Quad Trim Winding Interconnection on 21Q40 Half Cell Wiring Diagrams

BNL/SNS Technical Note
No. 136
R. F. Lambiase
June 2, 2004

I have reviewed seven wiring diagrams, all relating to 21Q40 installations. The drawings are 5300 074, 081, 082, 086, 099, 100, and 129. The trim wiring on all these drawings is correct for the depiction of the winding direction shown on the drawings.

Dwg 5300074

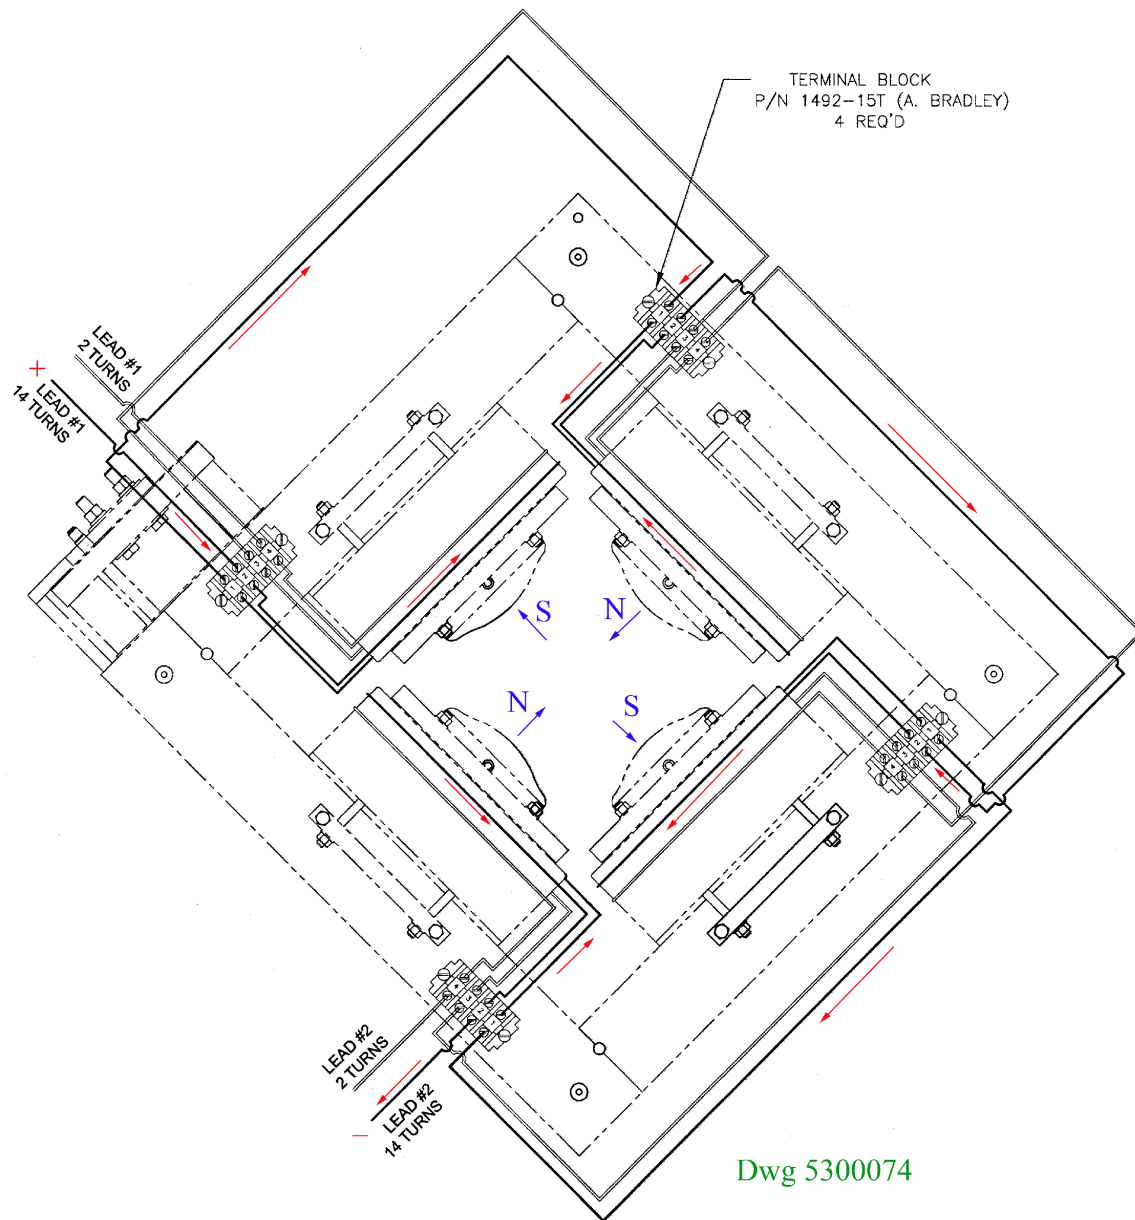
With a correct interconnection, a positive current entering terminal 1 will produce an “A” Polarity. I checked the drawings by marking up the relevant portion of each. The results are attached as a reference.
